In the Matter of)
)
AMERGEN ENERGY COMPANY, LLC)
)
(License Renewal for the Oyster Creek)
Nuclear Generating Station))

NUCLEAR INFORMATION AND RESOURCE SERVICE, JERSEY SHORE NUCLEAR
WATCH, GRANDMOTHERS, MOTHERS AND MORE FOR ENERGY SAFETY,
NEW JERSEY PUBLIC INTEREST RESEARCH GROUP, NEW JERSEY SIERRA
CLUB AND NEW JERSEY ENVIRONMENTAL FEDERATION
(COLLECTIVELY "CITIZENS")
REPLY TO NRC STAFF AND AMERGEN RESPONSES TO
COMMISSION ORDER DATED MAY 28, 2008

Subject: Discussion of Sensitivity Analyses Proposed
By NRC Staff and AmerGen

Subject: Technical Commentary on Structural Analyses, Oyster Creek Drywell Vessel

Contour Plot for Bay 1
External UT Measurements 2006

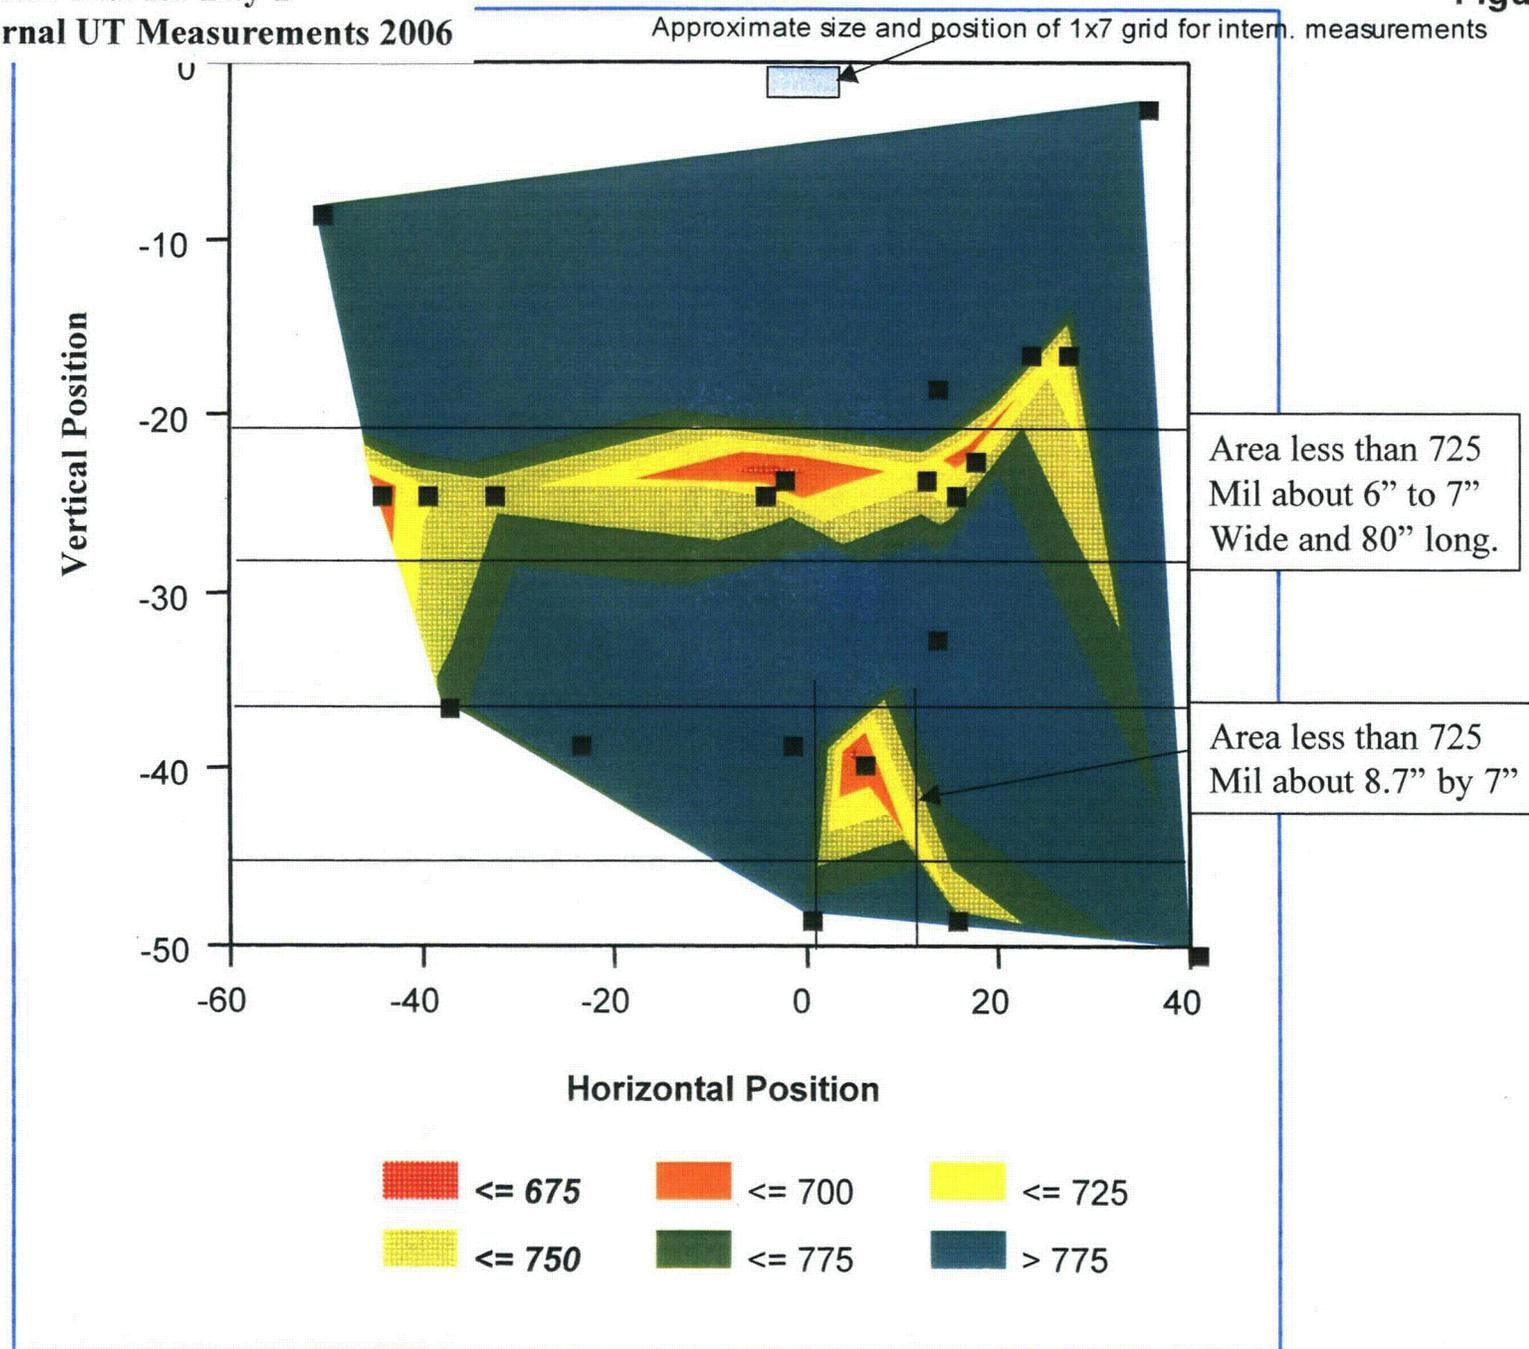
Bay 1: The internal measurements in Bay 1 were made with a 1x7 inch template. For comparison the template was drawn into the graph at the 0/0 location (Figure 3) where it most likely was located. As it turned out the internal measurements were non-representative of the corrosion in Bay 1 and therefore irrelevant. AmerGen realized this and went ahead to characterize this Bay 1 by way of the results obtained for Bay 19 because a) they are adjacent Bays and b) because they were both the most corroded ones. However, AmerGen uses the internal grid measurements for Bay 19, the average of which was 826 mils (836 mils according to our calculations) rather than the average of the external measurements of Bay 19 the average of which was 801 mils. (As it turns out the averages of the external measurements for Bays 1 and 19 are most nearly identical.)

There is still an additional difficulty to which Judge Barrata alluded. The external measurements in Bay 1 extended over the Bay from - 40 inches of center to + 40 inches. The Bay however extends to roughly 120 inches on either side. Therefore less than 30 % of the Bay was covered with external measurements. The contours drawn in Figure 1 for Bay 1 suggest that the "bath tub ring" of severe corrosion might well extend the entire width of the Bay. This is another uncertainty which modeling must take into consideration by way of a sensitivity analysis. Finally, Judge Barrata decided that from a structural point of view it is preferable to use mathematical interpolation and extrapolation techniques to make the best possible estimate of the distribution of the thickness over the Bay, rather than averaging the remaining wall thicknesses over a broad area.

Contour Plot for Bay 3

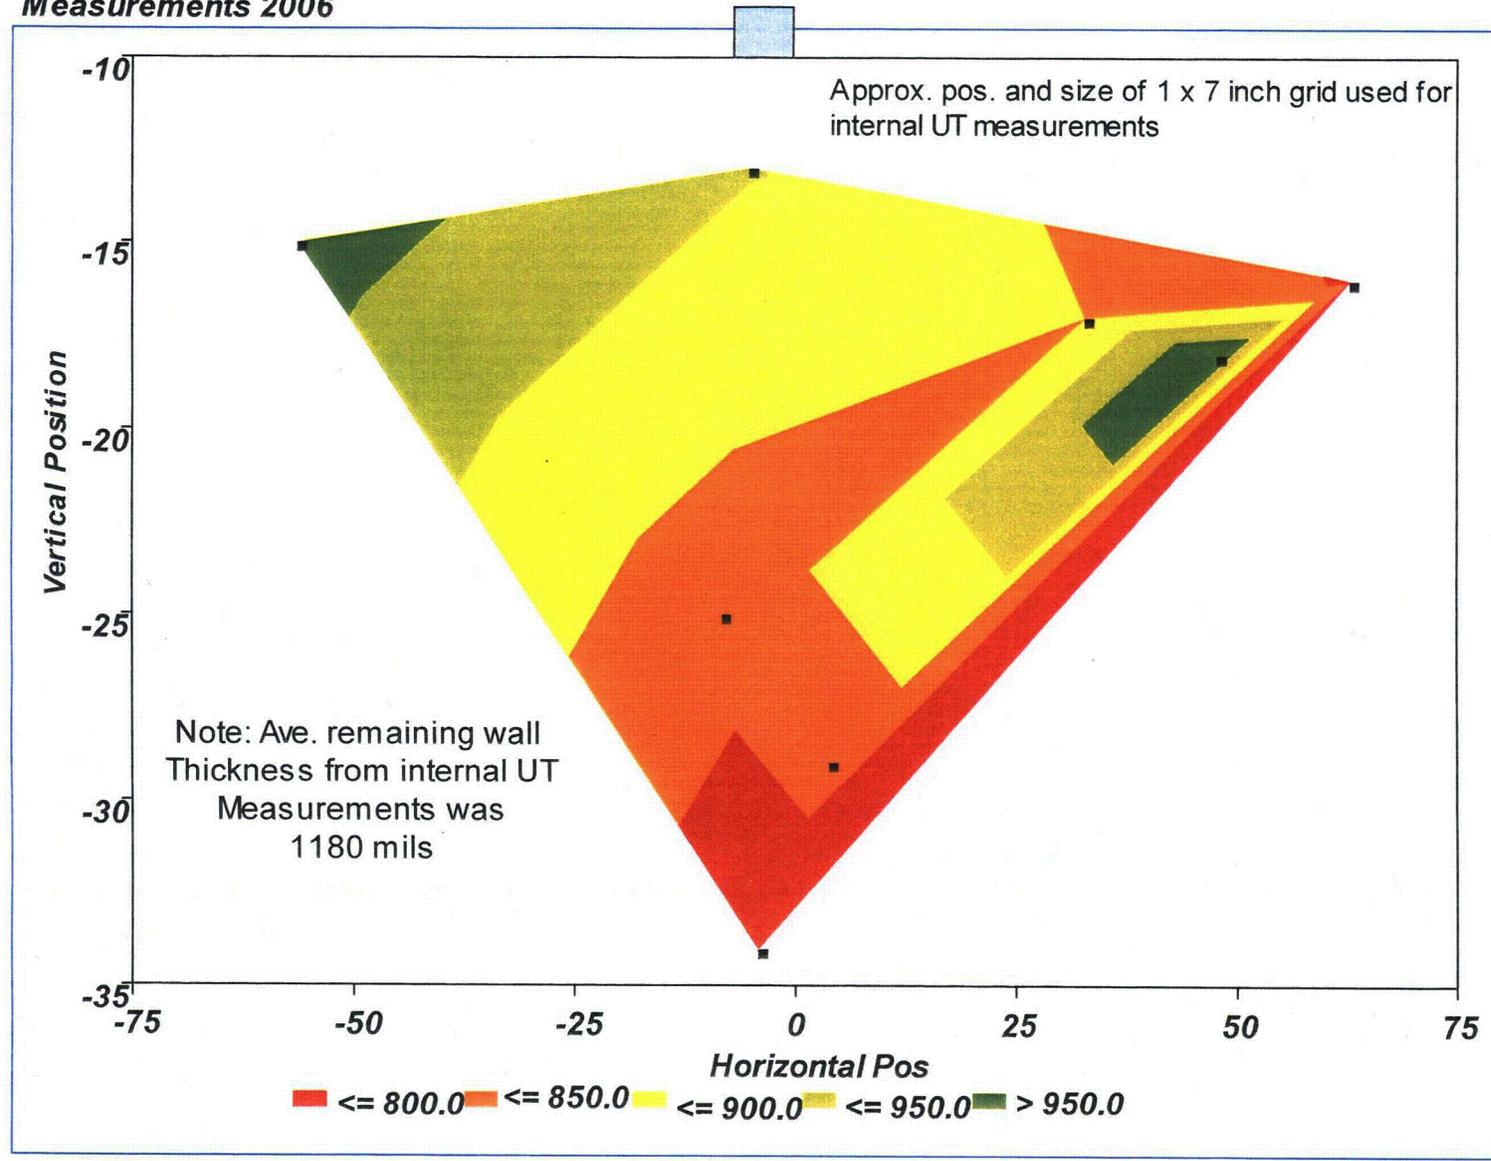
Bay 3: Figure 4 shows the contours for Bay 3. The internal grid measurements (1x7) are not representative of the corrosion in that Bay. For this reason AmerGen creates a complex argument which should justify using data from Bays 1 and 5 below 11'0" for an average of 950 mils. However, again the average for the external measurements in Bay 3 is 865 mils. AmerGen has failed to justify how 950 mils can be a conservative thickness estimate for the average thickness of this this Bay when average of the external measurements in this Bay is 865 mils.

**Contour Plot for Bay 5
Measurements 2006**

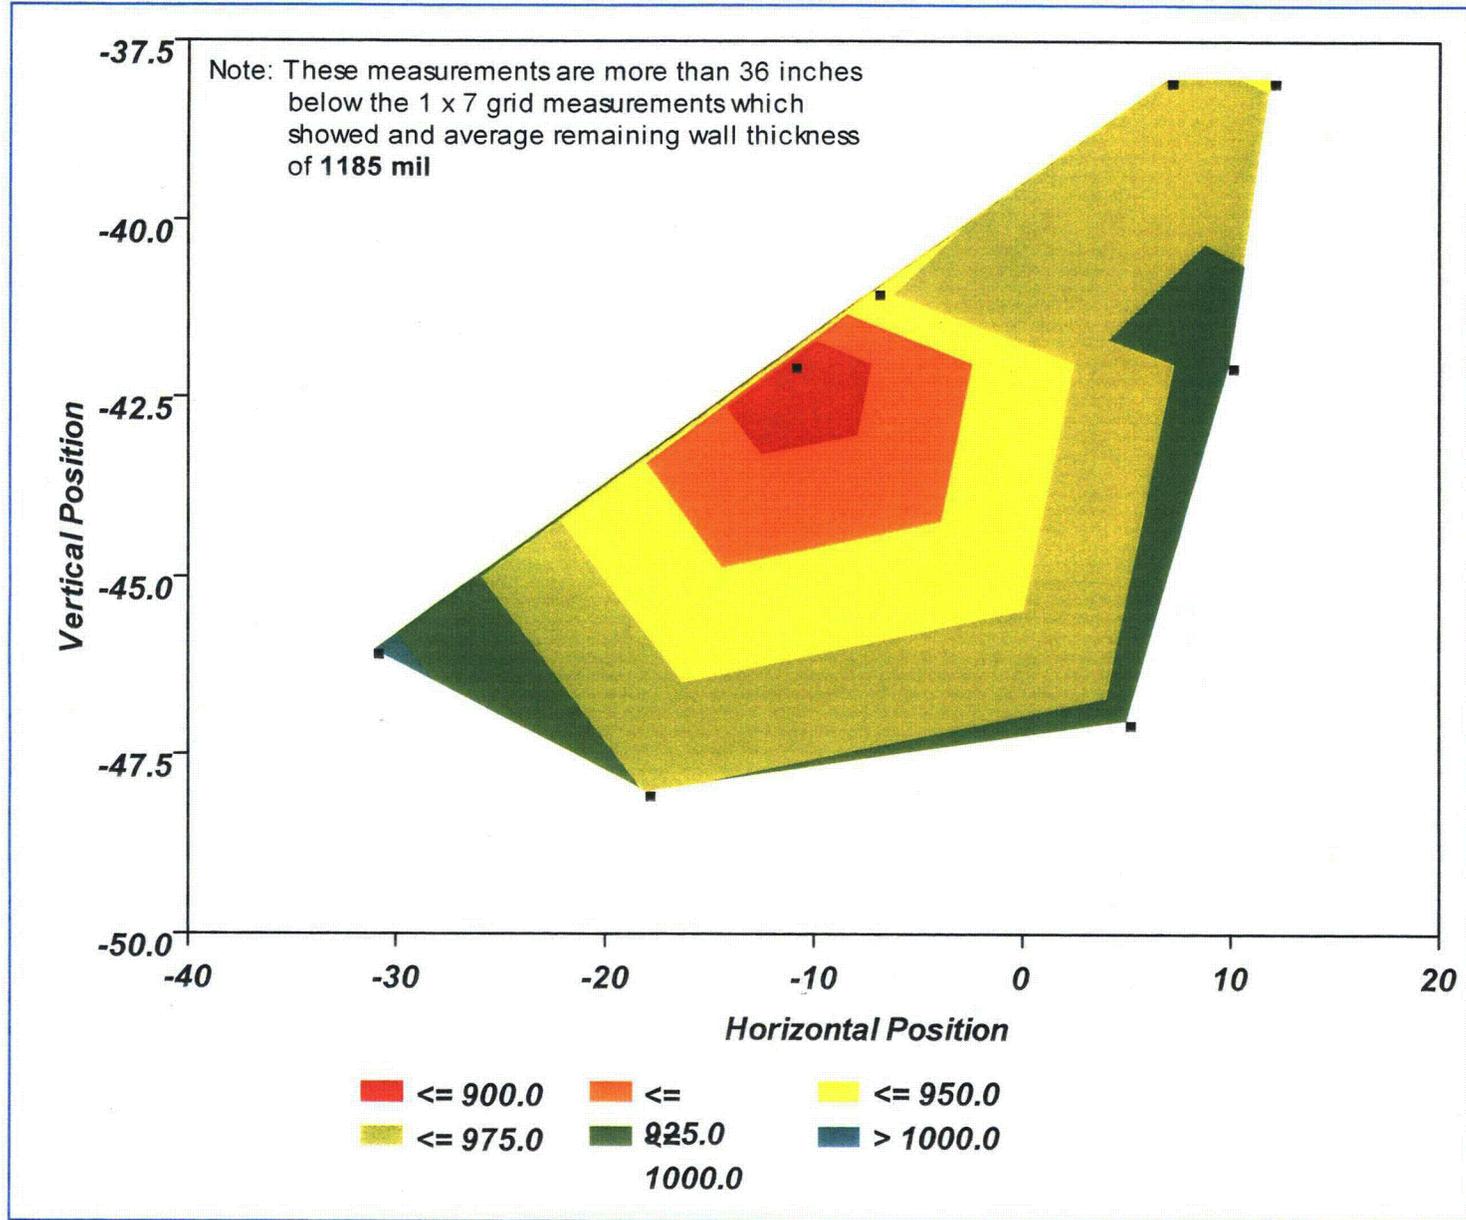
Bay 5: Here too one finds the internal grid results to reflect no corrosion (Fig 5). It is noted that the external measurements were made very low near the bottom of the sandbed and indicate on average a 20% deterioration over the nominal wall thickness.

Contour Plot for Bay 7

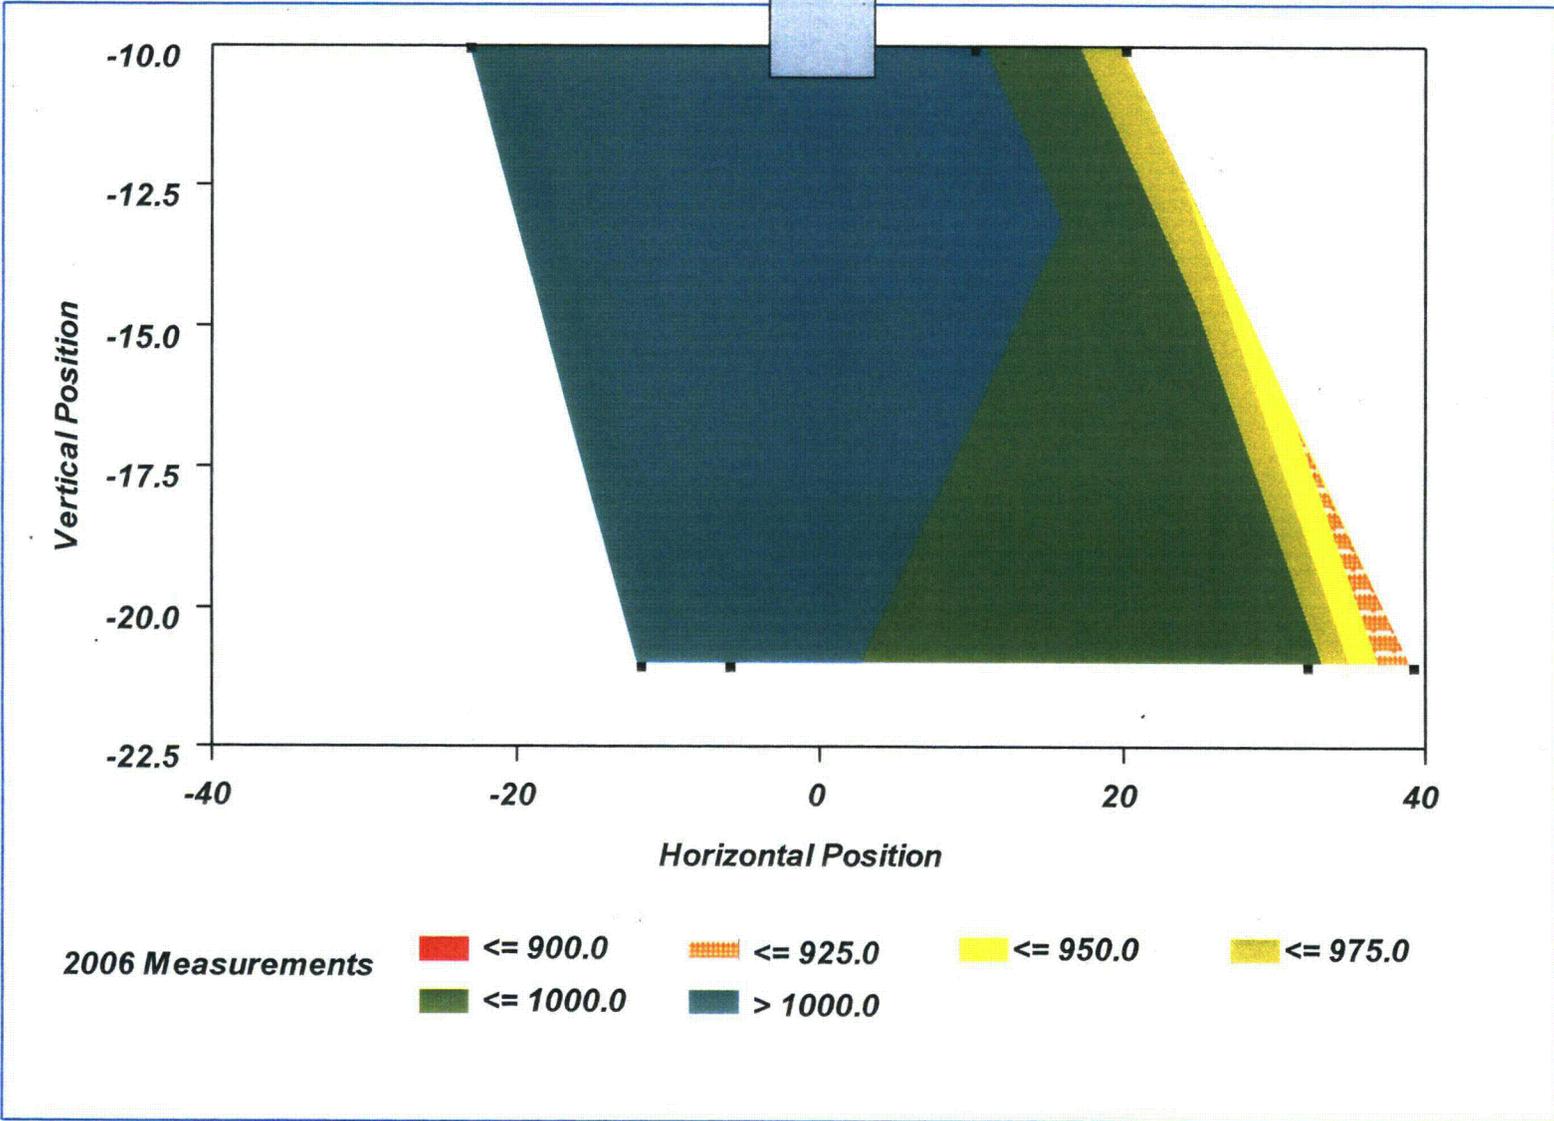
Bay 7: As Figure 6 shows only 7 external measurements were made in this Bay. There was additionally some confusion about certain points from 1993 which could not be repeated in 2006. Adjusting for this, the external average remaining wall thickness is 995 mils. The internal measurements returned nominal wall thickness. AmerGen however determines an average thickness of 1034 mil for the wall below 11'0", a number apparently based on some averages from Bays 5 and 9. Additionally, it appears that there was some significant corrosion in this Bay (see Fig. 6) which AmerGen choose to ignore and not further investigate.

Contour Plot for Bay 9 using 2006 Data

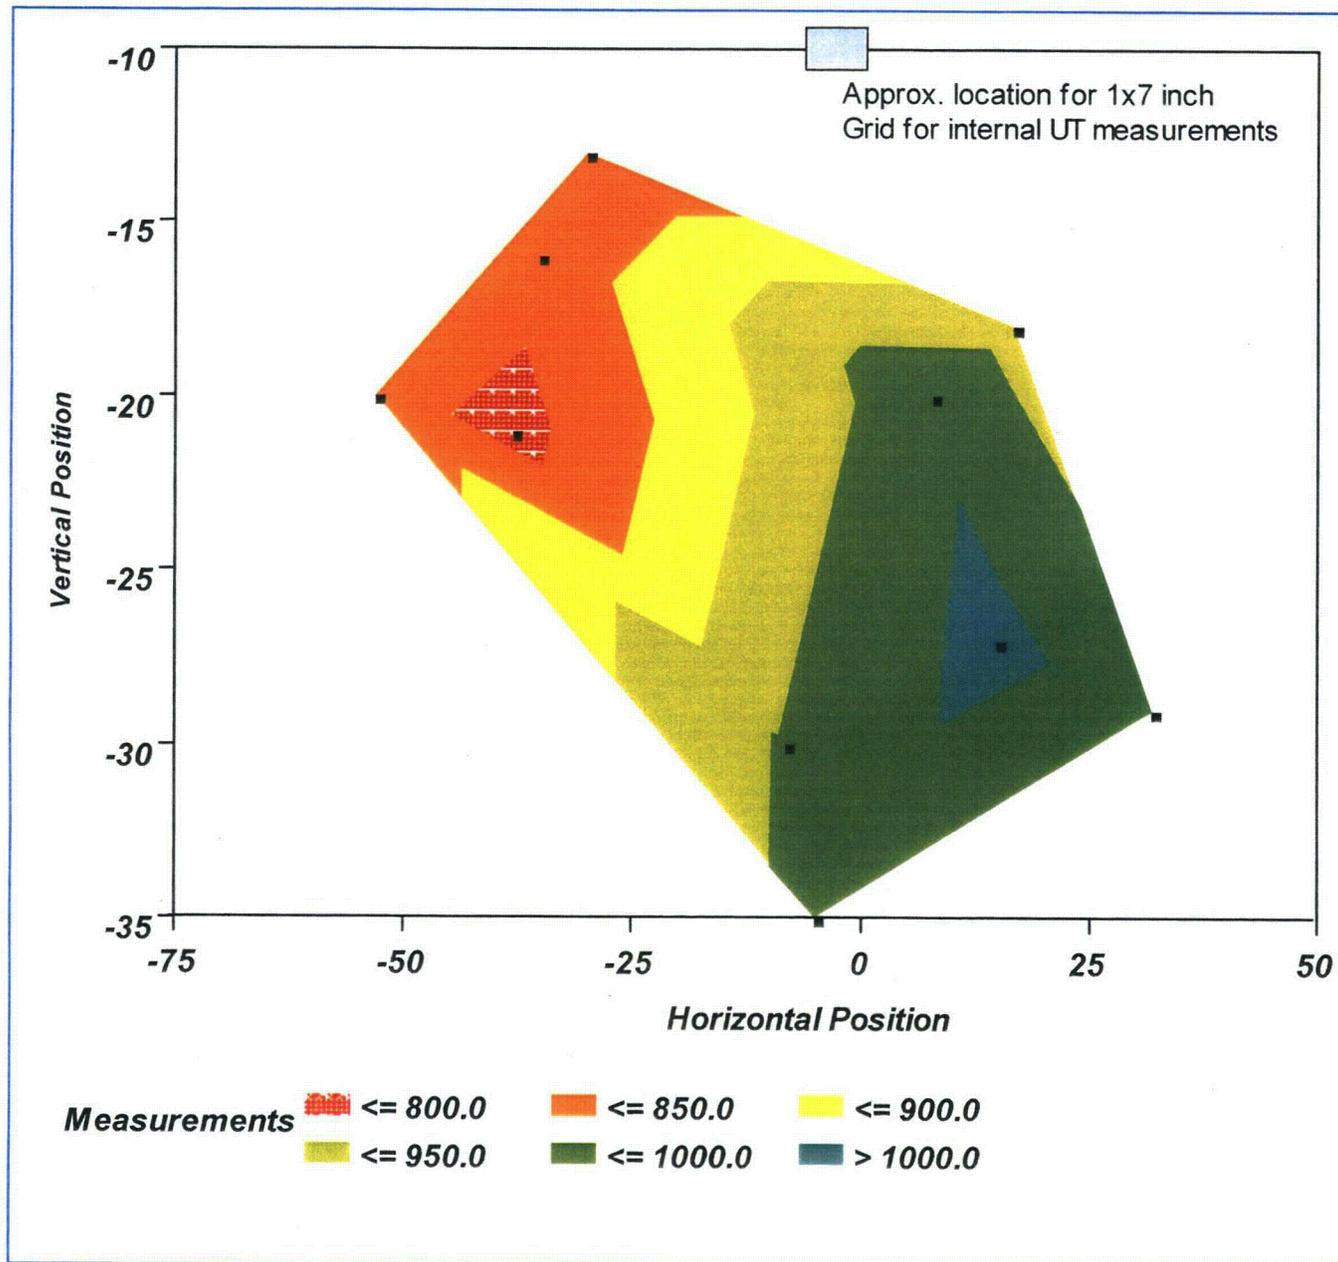
Bay 9: As shown in Figure 7 10 external measurements were made in an area of 1.5 ft by 7 ft. or barely 15% of the total bay area. The average remaining wall thickness in that area was 905 mils or a reduction of 22% from nominal. The 1x7 internal grid showed no corrosion while the 7x7 grid returned an average of 988 with a standard deviation of 78 indicating fairly large variation between individual measurements (not instrument error). Note: AmerGen chooses the smaller of the two internal grid averages (993 mils⁶⁾) and disregards entirely the external measurements. Additionally, there is within the grid a top down drift toward the lower values of the external measurements indicating that the residual wall thickness in the area where the sand was is probably of the order of 903 mils rather than the 993 preferred by AmerGen.
